Port Authority of Allegheny County

North Shore Connector

Contract No. NSC-009

ADDENDUM NO. 7

CONTRACT NO.	NSC-009
DWG. NO.	TP016
SHT.	281

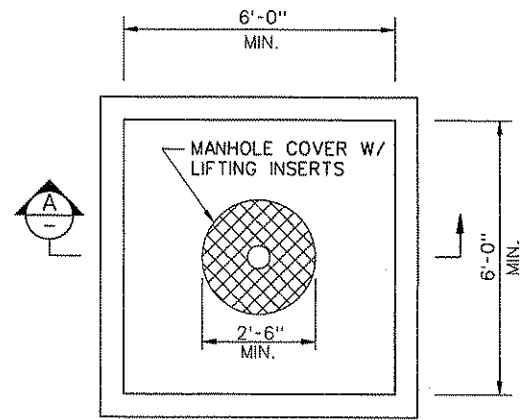
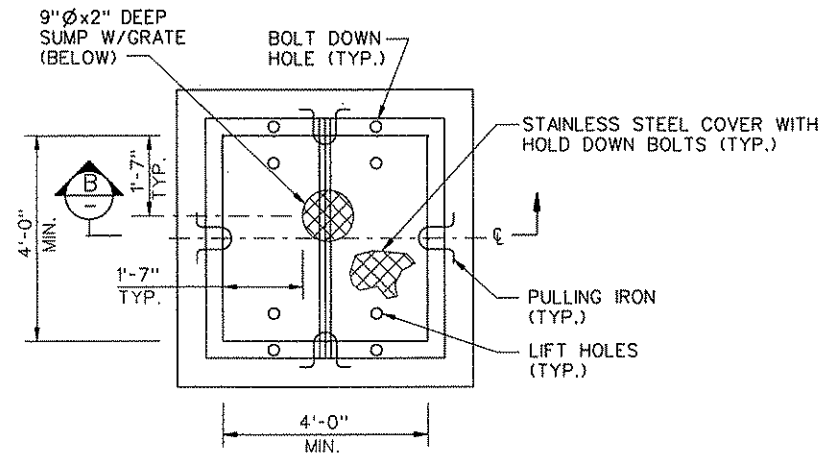
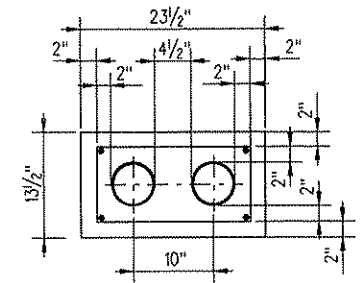
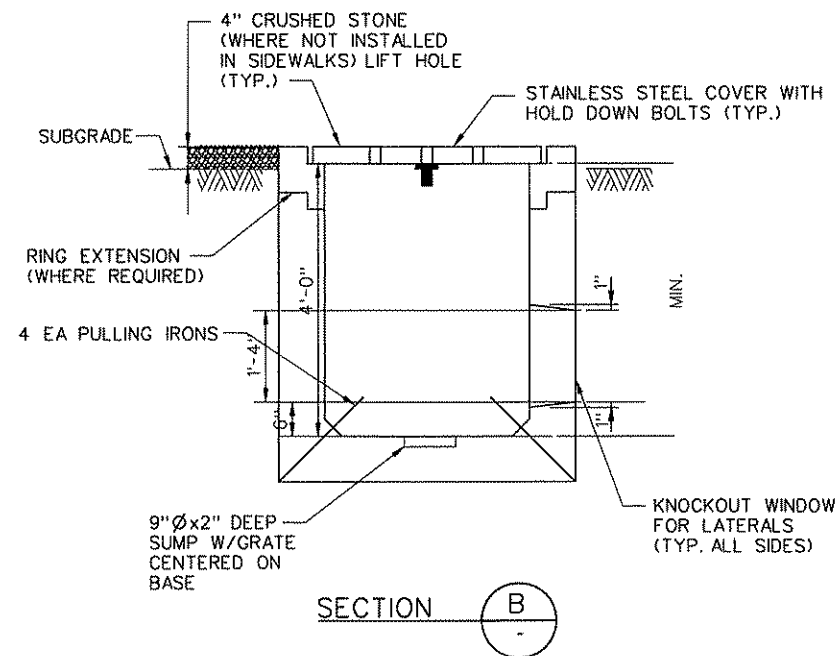
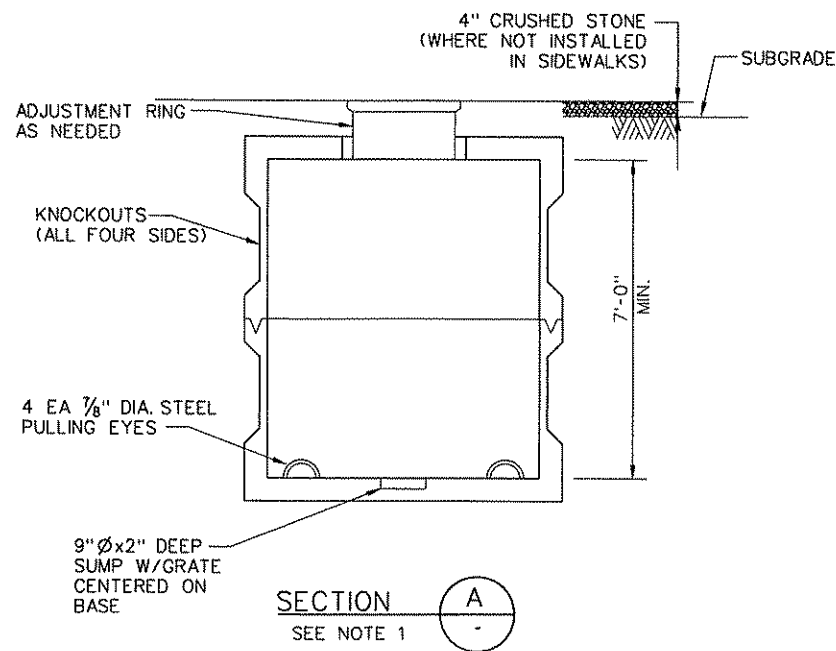
Question 149: Contract Drawing TP013 shows manholes ACMH 1 and ACMH 2. No dimensions manhole details are given. Please confirm that the furnish and install of these manholes is included in the NSC-009 contract and provided details on each of the manholes.

Response 149: Manhole drawings are shown on drawing TP-018. See Addendum 7 for clarifications.

CY-111 T1373 TS-15 DOUBLE LINE TRACK & SIGNAL PLAN 4

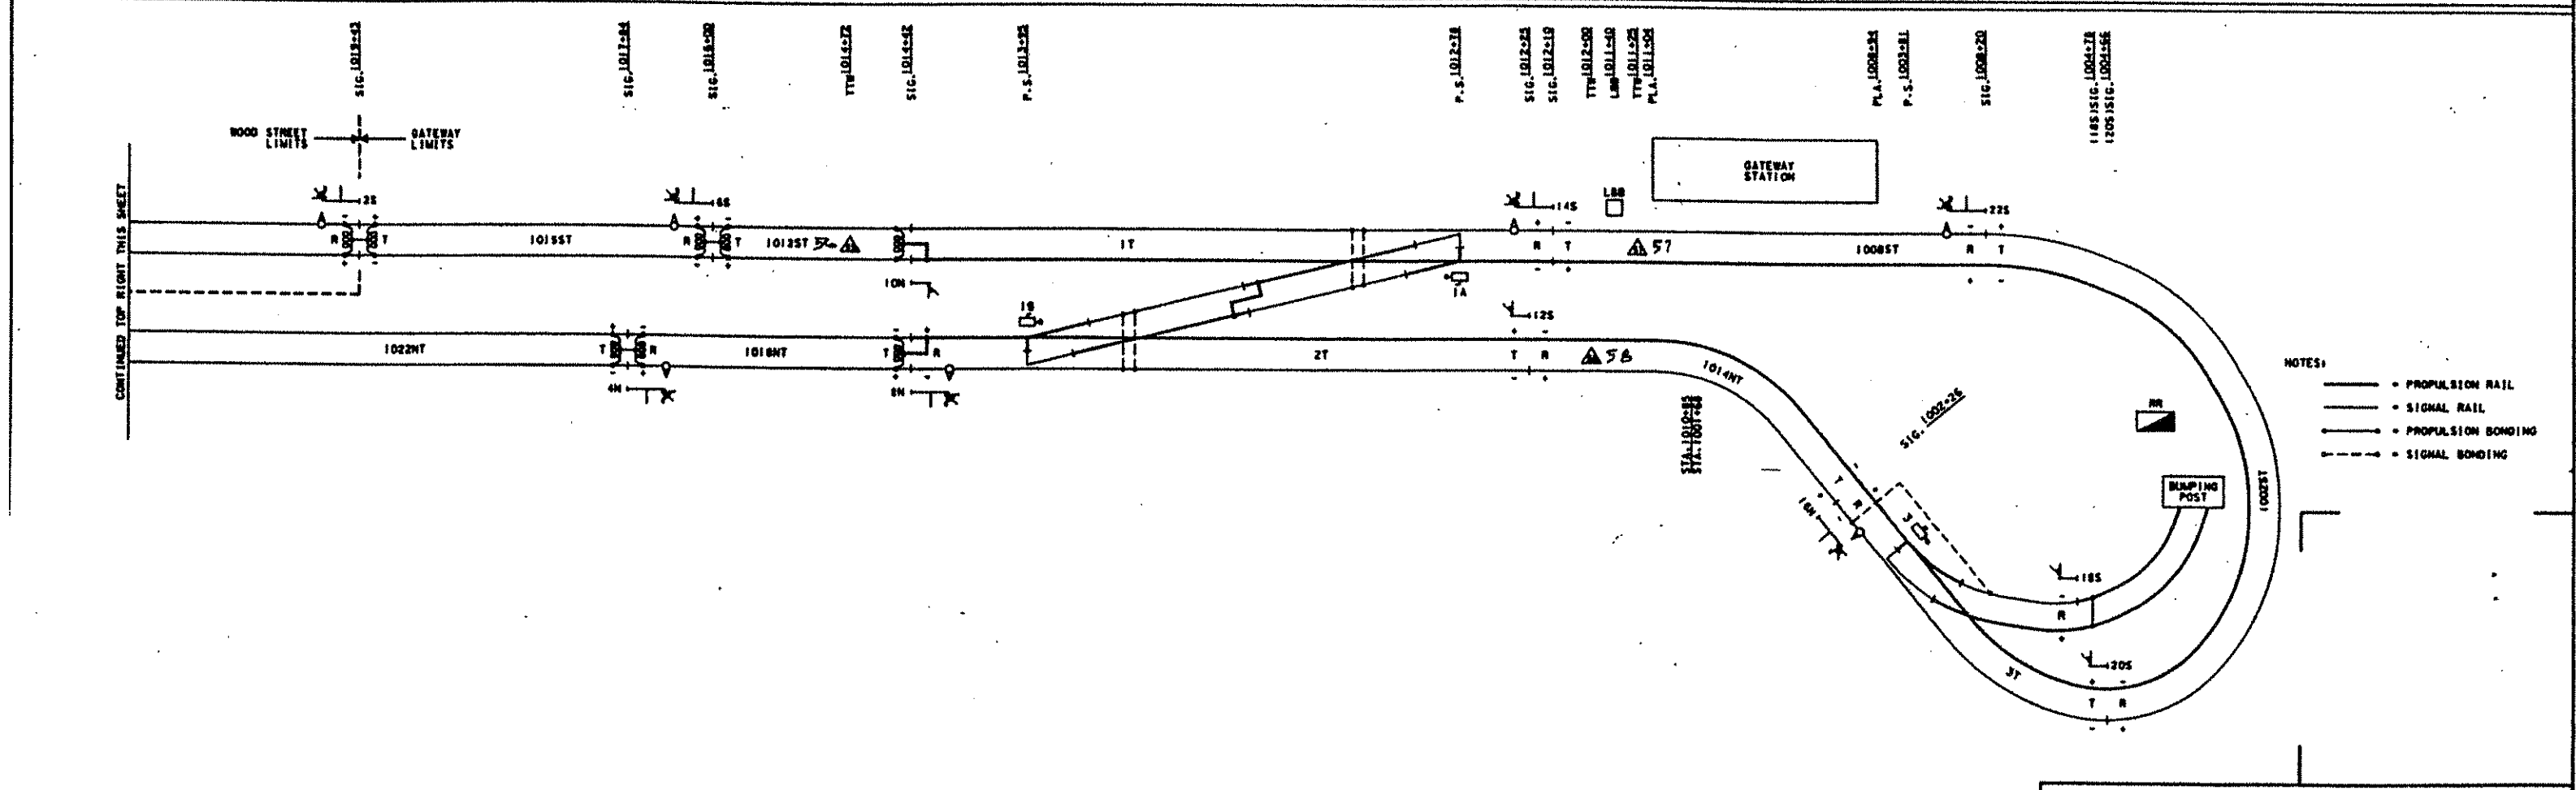
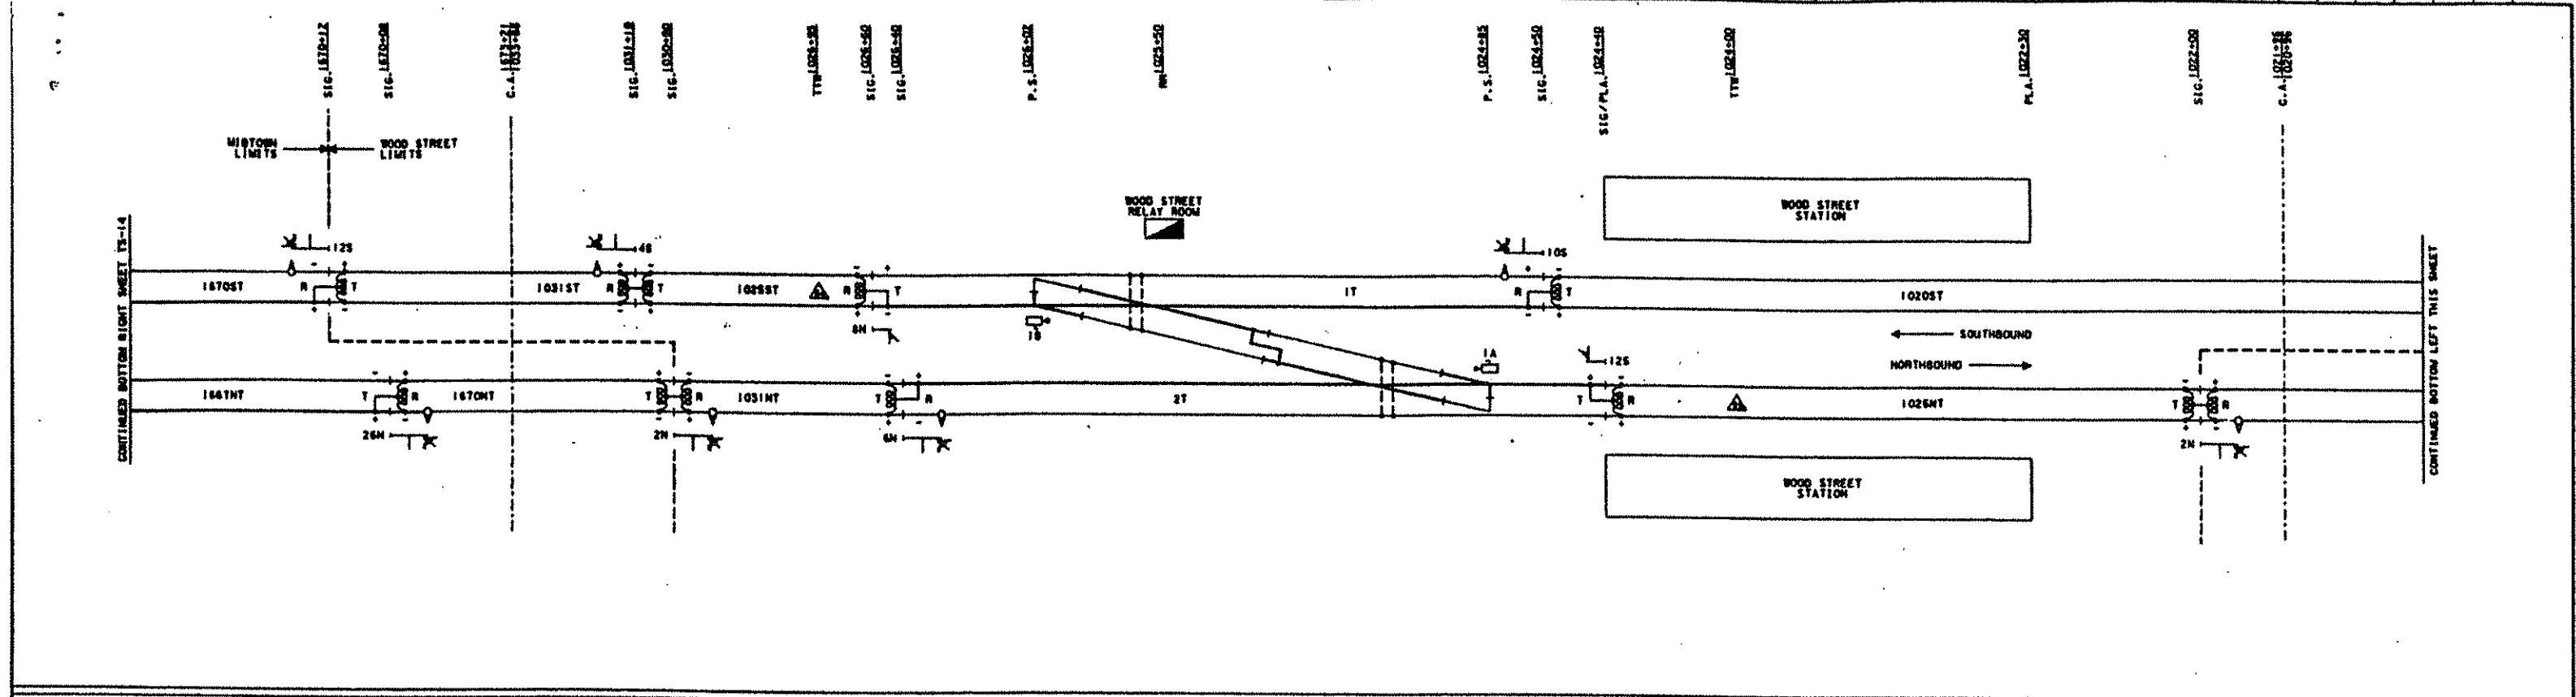
Question 152: Contract Specification 02220 "Demolition", Section 2.08 "Signal System" requires the Contractor to remove tunnel signals 16N, 18S, 20S and Electric Switch Machine #3. Please provide information as to the location of this equipment.

Response 152: Switch #3 and the 3 signals are located on Gateway Loop. Gateway layout added to Also Drawings. See Addendum 7.
